# **Draft determination of causer: 21 December 2024 under-frequency event**

Consultation paper

### **The Authority's draft determination is that the grid owner was the causer of the 21 December 2024 UFE.**

System Operator event 4523

Figure 1: Graph of Frequency and Generation in Hawke's Bay during the 21/12/2024 UFE

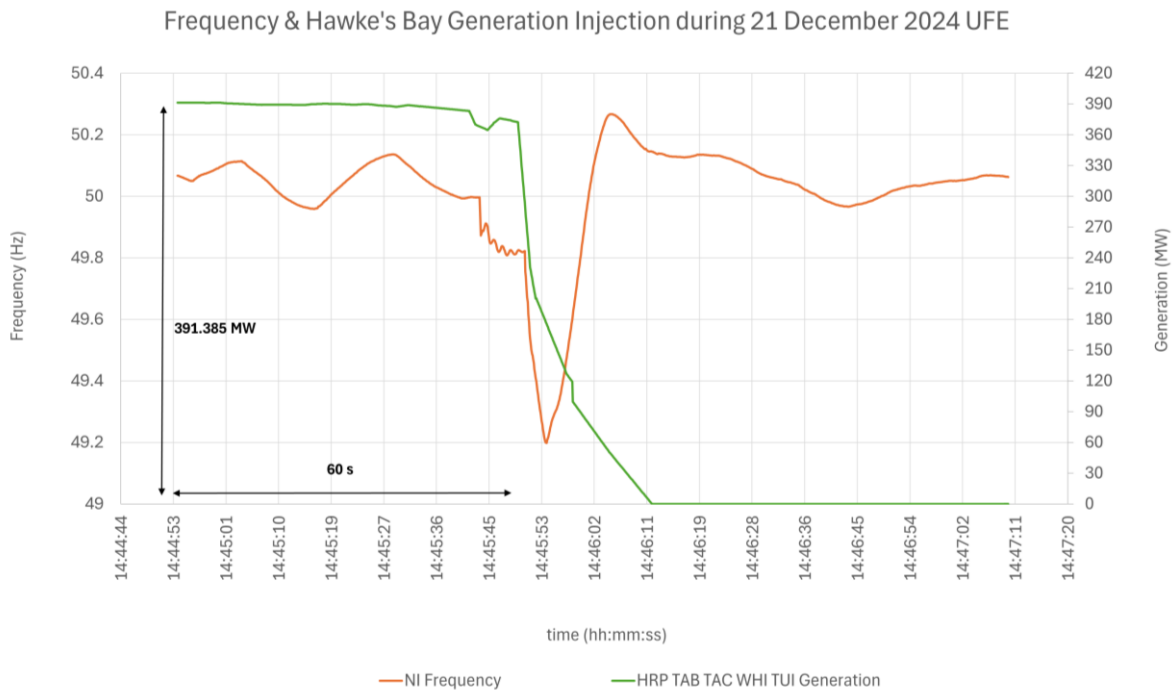
Please note *the System Operator's graph above may not map precisely to tripping of the Hawke's Bay generation. This is because there is a time delay in the System Operator's SCADA data.*

Figure 2: Translation of information

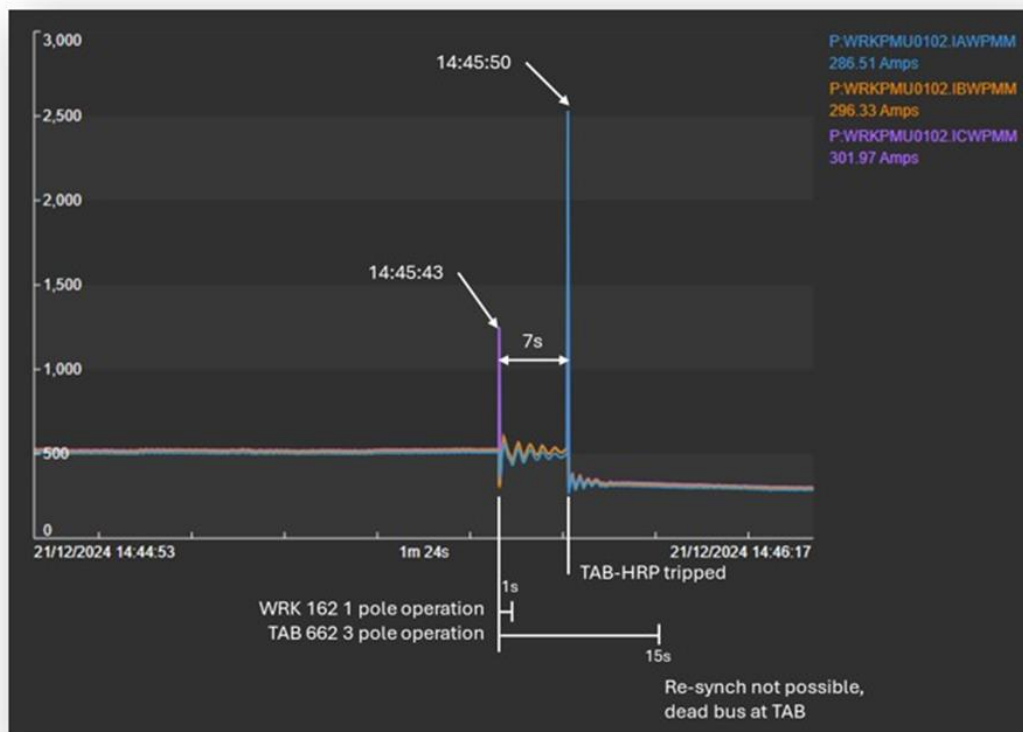
- ii. In the information provided, you stated that WRK CB 162 successfully reclosed for the same fault at 14:45:43. There was no clarification on why two relays sensing the same fault responded differently. I have a figure 2 below that translates the information provided by the Grid Owner. Kindly clarify this. [GO] Due to the highly meshed nature of a transmission power system, it is common for the same fault to appear differently to relays at either end of the protected circuit. The location of the fault, the source impedance behind each relay, and the impedance of the fault all impact the currents and voltages measured by the relays during a fault. In this specific case, the fault was electrically closer to WRK, and with WRK having a lower source impedance than TAB, this resulted in higher current and more voltage depression measured at the WRK end of the circuit.
